# Product Change Notification

## 107439 - 00

**Change Notification #:** 107439 - 00  
**Change Title:** Intel PRO/1000 GT Desktop Adapter,  
PWLA8391GTG2P20 MM#867728  
(Stebbins II LF G2, OEM generic)

**Peoples Republic of China (PRC) Environmental  
Friendly Use Period (EFUP) Label,  
Recycle Label, Peoples Republic of China (PRC)  
Materials Declaration Flyer, and Standardizing 3n1  
Label Size**

**Recycle Label**  
size 45.00mm x 45.00mm, black ink

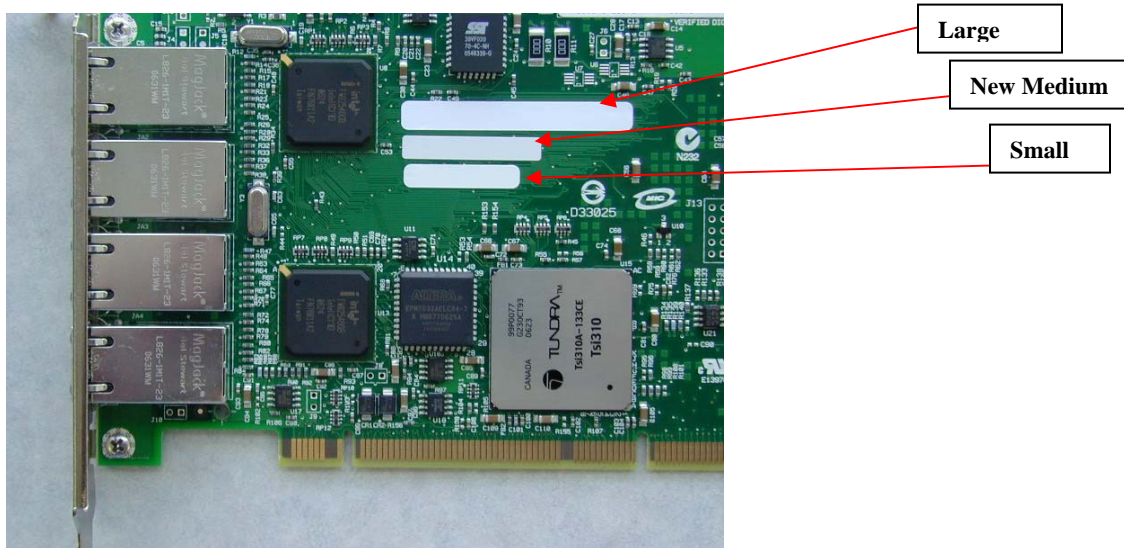
**Intel will add a Recycle Label to all of the Networking Adapter cardboard boxes:**

- Placement of this recycle label will vary based upon space constraints. **Recycle Label shown in the picture below.**
- All products shown in the Affected Products Table within this PCN notification will include this new Recycle Label.
